**UNITED STATES
NUCLEAR REGULATORY COMMISSION
REGION II
SAM NUNN ATLANTA FEDERAL CENTER
61 FORSYTH STREET SW SUITE 23T85
ATLANTA, GEORGIA 30303-8931**

SUBJECT: NRC INSPECTION REPORT NO. 70-1151/2004-001

Report No.: 70-1151/2004-001

Commercial Nuclear Fuel Division NRC Inspection Report 70-1151/2004-001

Figure 2

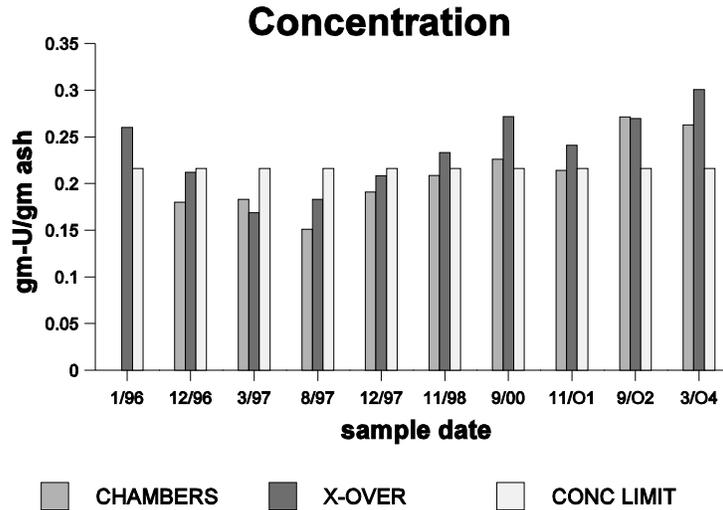
From September 1996 until March 5, 2004, the licensee increased control of burn residence time to improve compliance with environmental regulations and reduced burning of inert materials to reduce solids in the ash which were difficult to clean out of the incinerator. Longer residence time reduces carbon content of the resulting ash thus increasing uranium concentration and allows more time for fly-ash to carry over from the lower combustion chamber. Reduction of inert materials into the incinerator also increases the uranium concentration in the ash. These steady and uncontrolled process changes resulted in gradually increasing uranium concentration throughout the system as shown in Figure #2:

The licensee did not remove material from the upper combustion chamber during every shutdown so that accumulation of mass was likely. Accumulation of sufficient mass in the upper combustion chamber at a concentration that would support criticality is considered credible. Both mass and concentration are seen to increase in Figures #2 and #3 indicating progression of the upset.

Figure 3

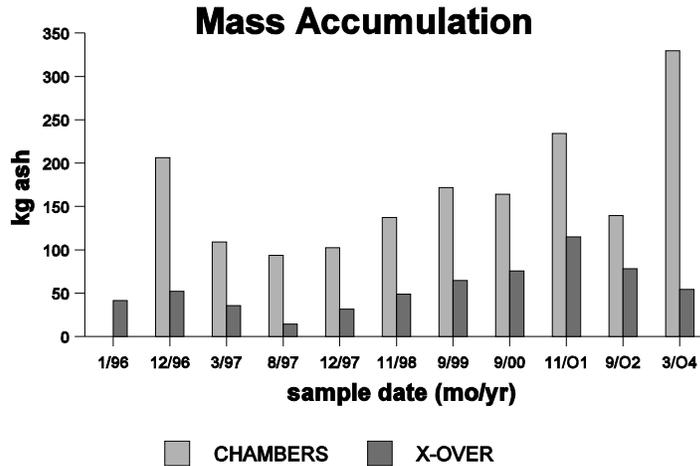
The process changes also resulted in a gradual increase in the amount of ash deposited particularly in the upper combustion chamber and cross-over pipe as shown in Figure #3:
